REFUSAL OF PLANNING PERMISSION

Site location: 51 Weymouth Road Hayes

Description:
Erection of a two-storey side extension and single-storey rear extension.

Item No. **Report of the Head of Development Management and Building Control**

LOFT FLOOR PLAN - 1:50

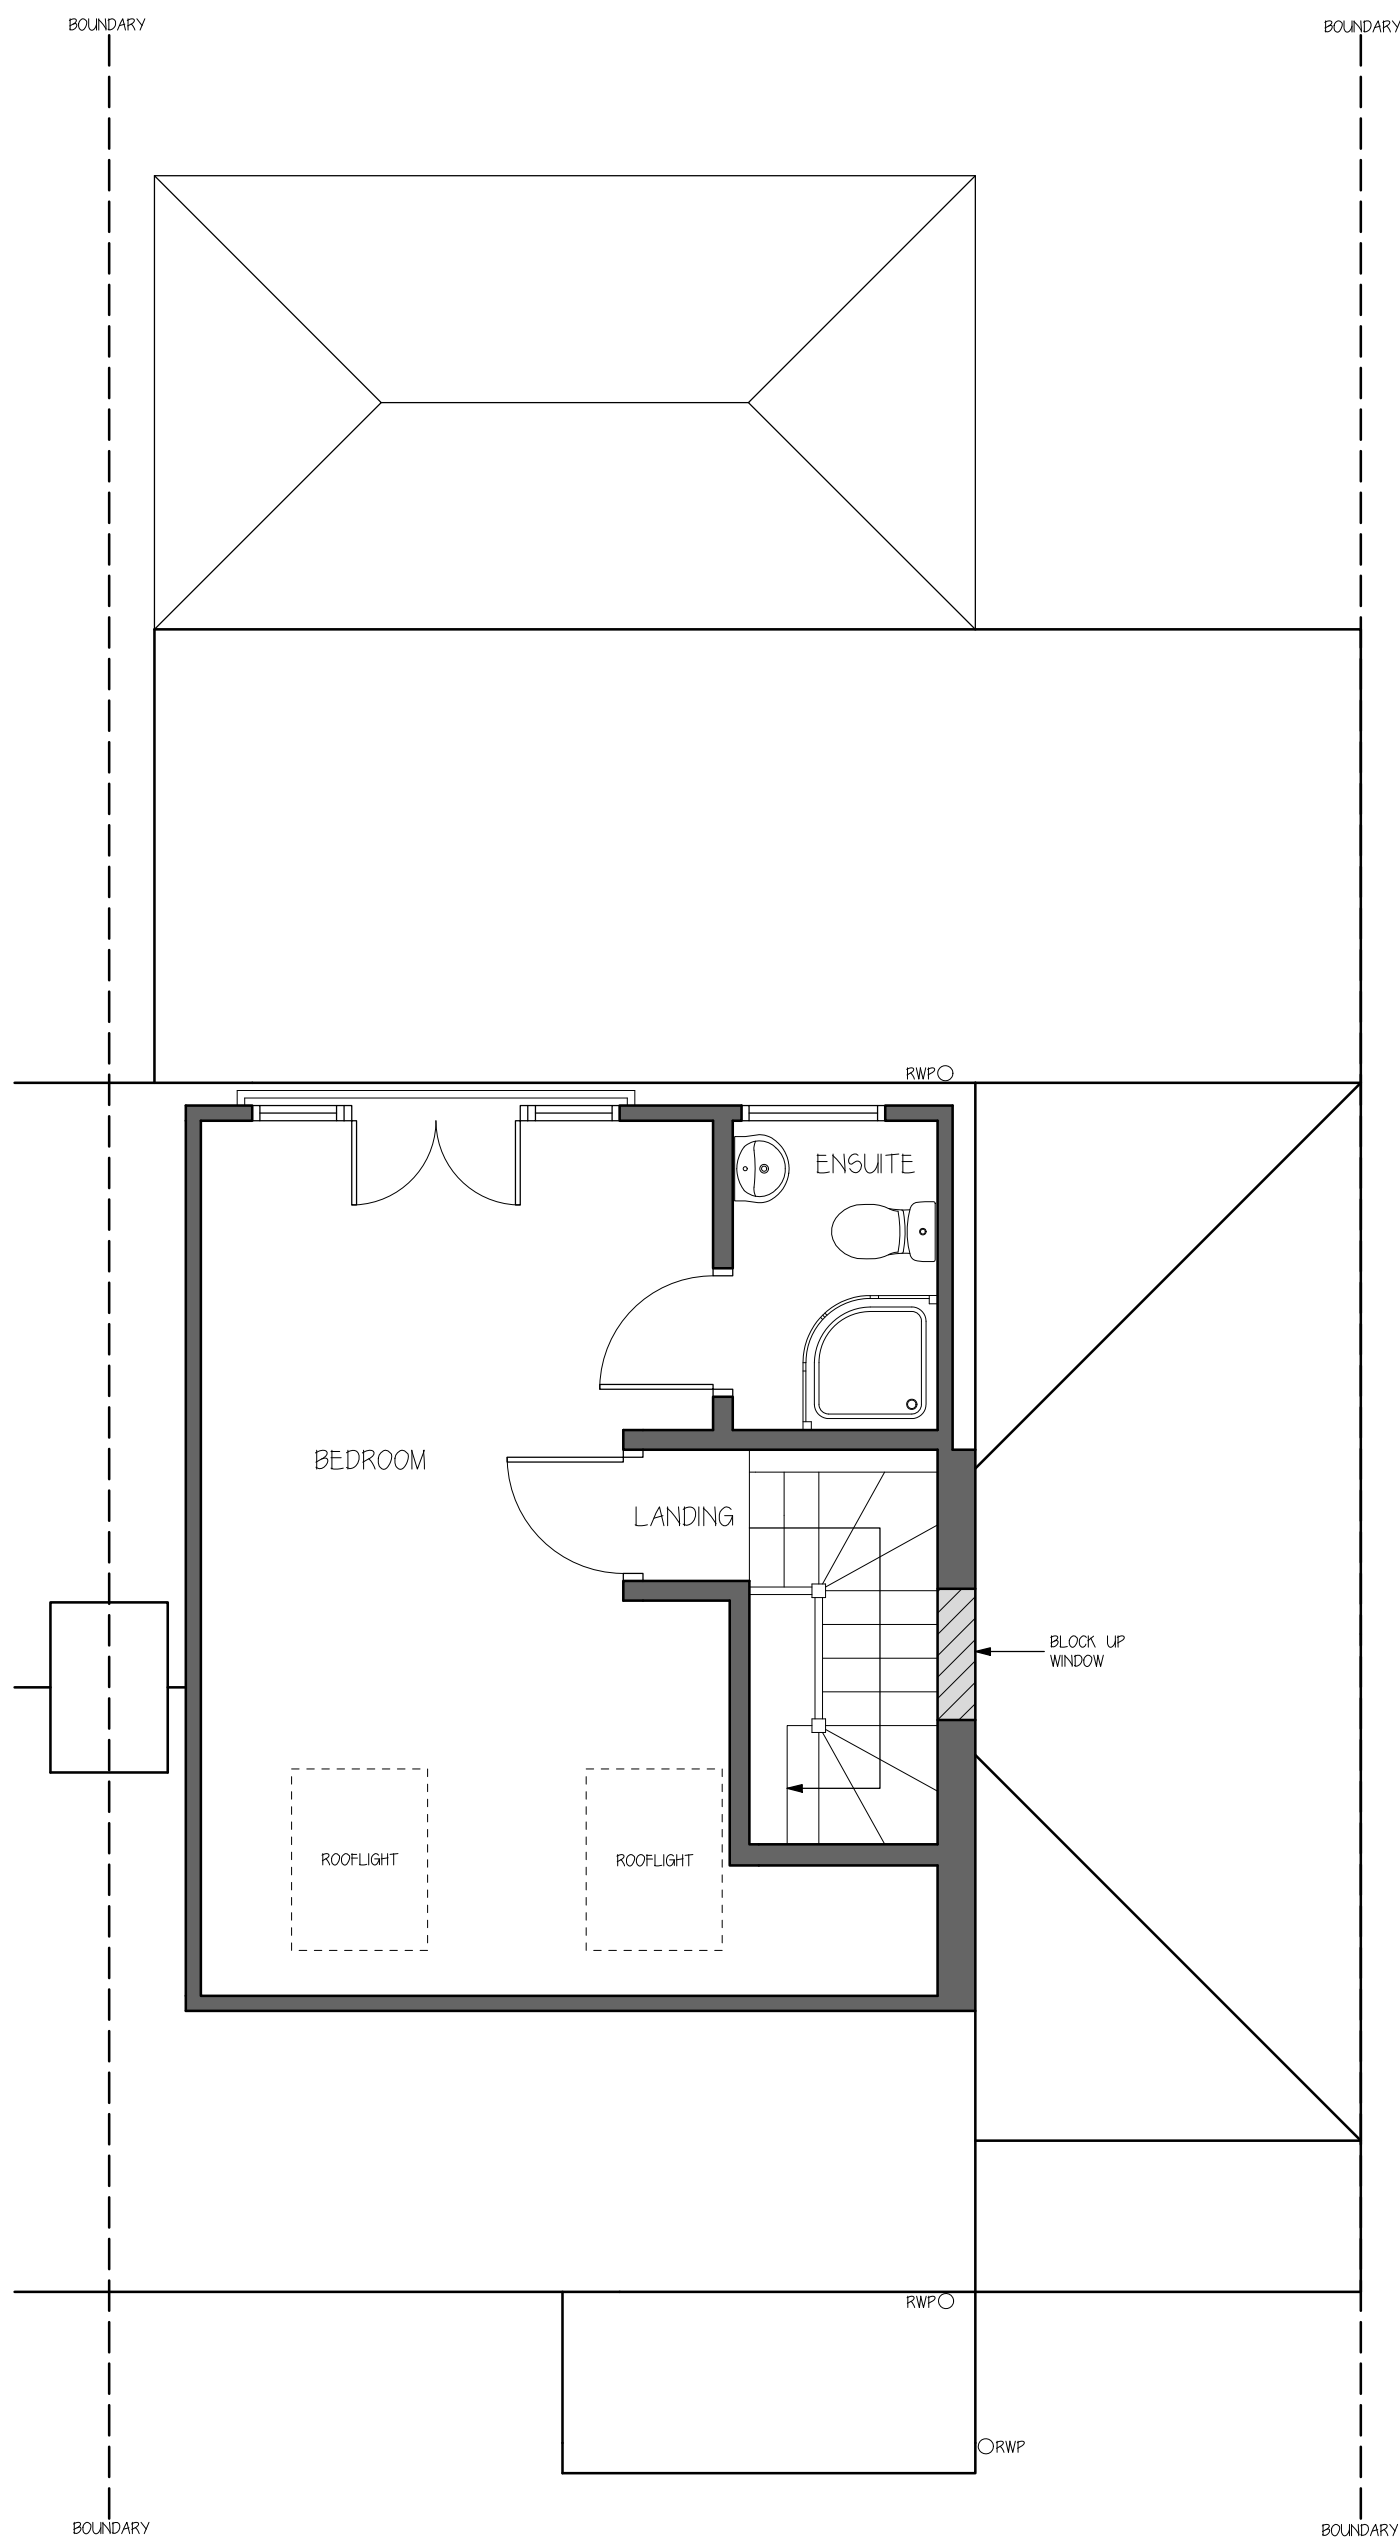
The proposal would create a two-storey side extension with a single-storey rear extension. The scheme differs from that which was dismissed at appeal (Appeal Ref: APP/R5510/D/23/3333501) in that the first floor would be set back 1 metre (compared to 500mm set back of the dismissed proposal), and the roof would be hipped (compared to the gabled dismissed proposal).

The two-storey side extension would be less than half the width of the original dwelling, with the ground floor following the building line of the front elevation and the first floor being set back 1 metre. The first-floor side extension would have a hipped roof form, with its ridge set down approximately 0.95 metres from the existing roof's ridge line. The side extension would run along the side boundary.

The current proposal differs from that which was considered at appeal in that the extension would be set under a hipped roof, set down from the main ridge. The hip could be considered to add some balance to this semi-detached pair. However, it would be at odds with the gabled roof form of the host dwelling. The Inspector's comments with respect to the character of the area and two-storey side extension are relevant in this case. The Inspector advises:

Officers acknowledge that attempts have been made to address the previous concerns about symmetry but consider that the proposal fails to overcome the concerns relating to visual amenities. The proposed two-storey side extension, by virtue of its size, scale, bulk, and design, including the awkward juxtaposition of the proposed hipped roof with the existing roof works, would fail to harmonise with the architectural composition of the host dwelling and would be detrimental to the character, appearance, and visual amenities of the street scene and the surrounding area. The proposal is, therefore, contrary to Policy BE1 of the Hillingdon Local Plan: Part One - Strategic Policies (2012) and Policies DMHB 11, DMHB 12, and DMHD 1 of the Hillingdon Local Plan: Part Two - Development Management Policies (2020).

Furthermore, the two-storey side extension, by virtue of its proximity to the boundary, would result in the harmful loss of a first-floor gap, which would appear cramped and incongruous with the character and appearance of the wider street scene. As a result, the development as a whole would fail to comply with Policies DMHD1 and DMHB 11 of the Hillingdon Local Plan: Part Two - Development Management Policies (2020).

The proposed two-storey side element would be set up against the boundary with No 53 Weymouth Road. No 53 Weymouth Road has two upper windows on their side elevation facing the application site. Whilst one appears to be obscured and servicing a bathroom, the other window upper floor side-facing would be impacted through the bulk and massing of the proposal in such close proximity. However, given that this window would rely on 'borrowed light' from across the application site, it is not considered, on balance, that any amenity harms would be sufficient to warrant refusal. It is noted that there have been no objections.
